# MY01 MONITORING REPORT

Round Hill Branch Restoration Site  
Buncombe County, North Carolina  
French Broad River Basin - 06010105

DMS Project #100066

Date: February 10, 2023  
To: Matthew Reid, DMS Project Manager  
From: Adam Spiller, Project Manager  
KCI Associates of North Carolina, PA  
Subject: MY-01 Monitoring Report Comments  
Round Hill Branch DMS #7534, Contract 100066  
French Broad River Basin CU 06010105  
Buncombe County, North Carolina

**Table 1. Round Hill Branch Restoration Site (ID-100066) Project Mitigation Quantities and Credits**

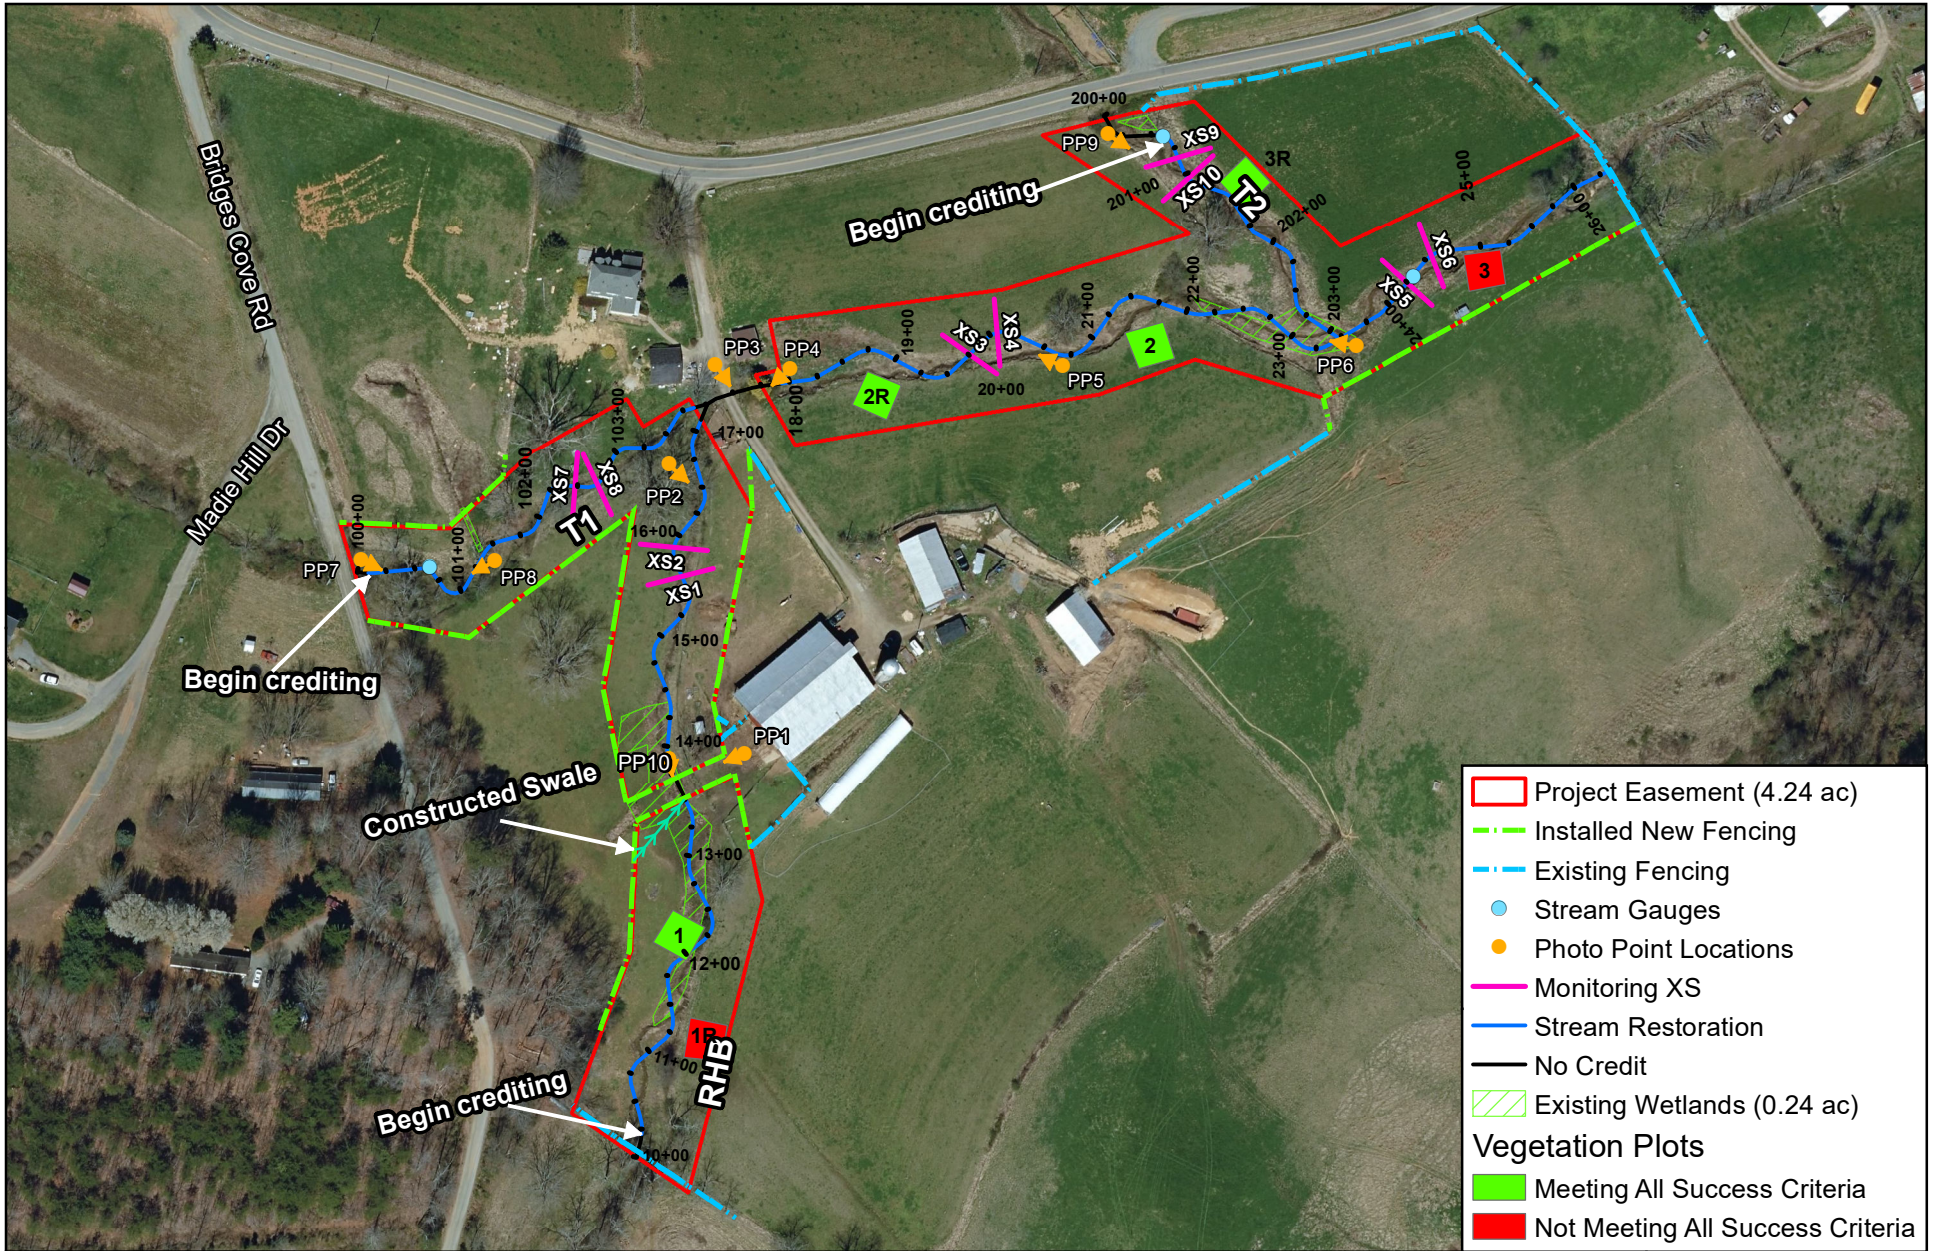
6. I noted a slight discrepancy in the stream credits calculated in Table 1. The As-Built length of streams is 2,242 feet and the length of streams removed for credit due to crossings is 114 feet. This results in a final credit amount of 2,128 cool SMUs. It appears that the stream segments removed from credit are tallied from the Original Mitigation Plan lengths (2,256 – 114 = 2,142). Recommend KCI take another look at these totals and correct if necessary.

*KCI Response: Credit lengths are generally calculated using the approved mitigation plan lengths unless there is significant deviation found during the as-built survey.*
